SHOREHAM NUCLEAR POWER STATION

SNRC-458

RESPONSE TO I&E BULLETIN NO. 79-02 REVISION 2

PIPE SUPPORT BASE PLATE DESIGN USING DRILLED-IN ANCHORS

FIGURE 1

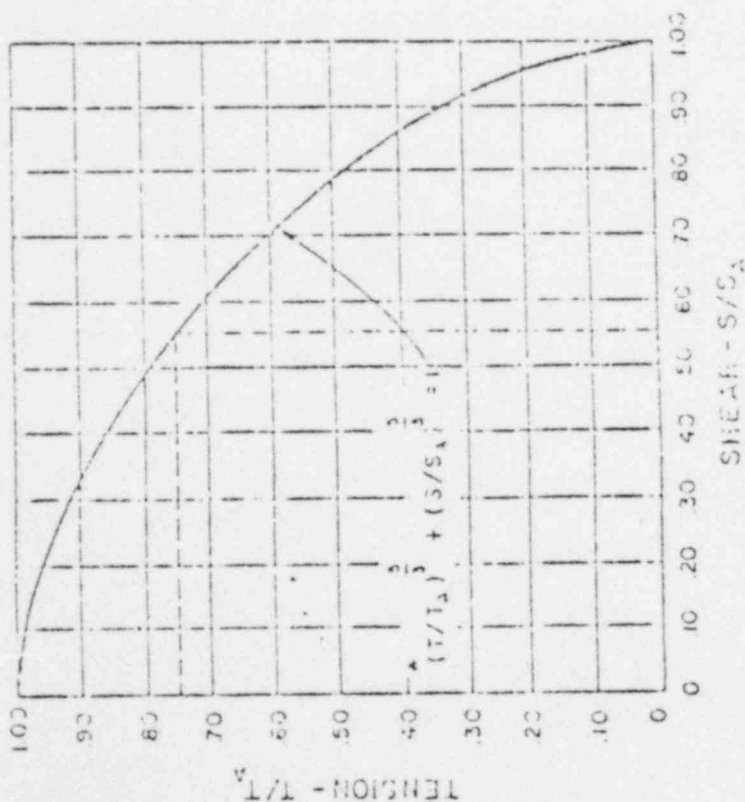
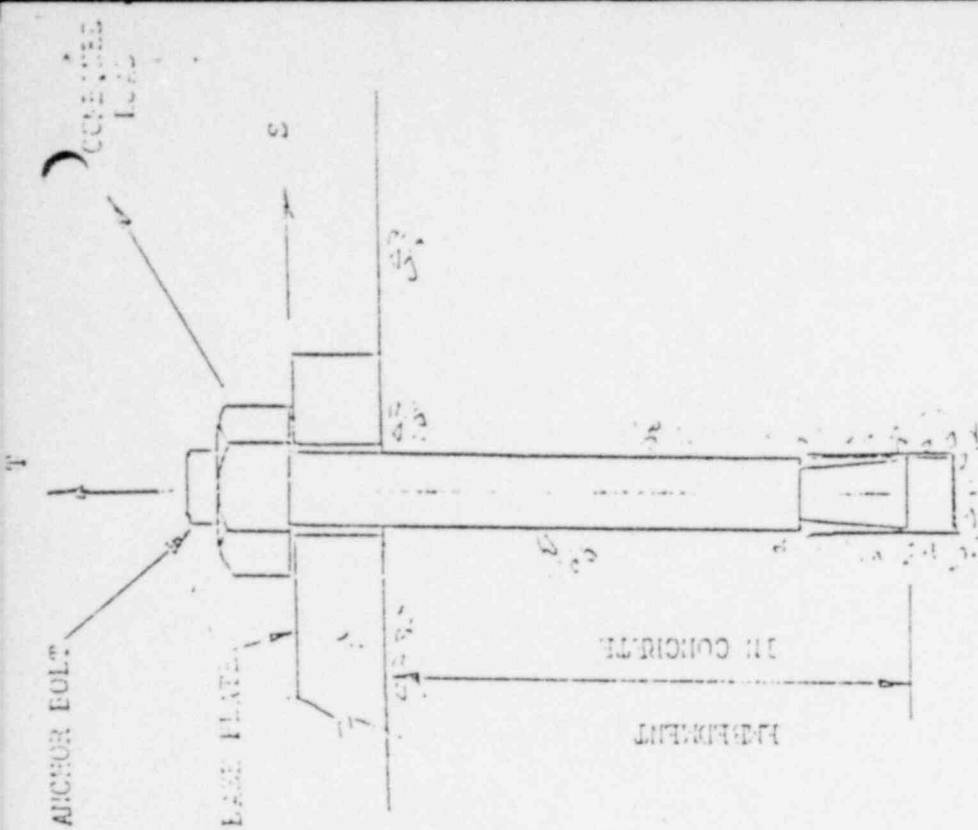
- ITEM (2) "Verify that the concrete expansion anchor bolts have the following minimum factor of safety between the bolt design load and the bolt ultimate capacity determined from static load tests..."

The anchor bolts used for component supports in the LILCO-Shoreham plant are the "wedge" type concrete anchor bolts. The **holding** capacity of these anchor bolts is derived from the expansion of steel wedges against the sides of holes drilled in concrete (eg., Hilti Kwik-Bolts). The tension/shear interaction diagram used for the anchor bolt design is shown in Figure 1, based upon the criteria given in Reference 1. The allowable tension loads for all anchor bolts are based upon the test results for Hilti Kwik-Bolts from an independent laboratory provided by the manufacturer (Reference 2), using a minimum safety factor of 4.0 on pullout. In addition to the use of Hilti Kwik-Bolts, Phillips Red Head and Universal Thunderstuds are also used. Manufacturer's data shows that generally the Phillips Red Head bolts have a higher pullout capacity than the Reference 2 data. The data available for the Thunderstud type bolts indicates that the loads are lower than those defined in the Reference 2 data for selective bolt sizes. Based on a concrete compressive strength of 4,000 psi, the factor of safety against pullout for these selective bolt sizes would be a minimum of 3.0. This is in agreement with the design requirements of ACI 349-76 "Code Requirements for Nuclear Safety Related Concrete Structures", Appendix B, Section B.7.2. The balance of Thunderstuds and all other wedge-type anchor bolts used in the Shoreham Plant have a minimum factor of safety against pullout of 4.0.
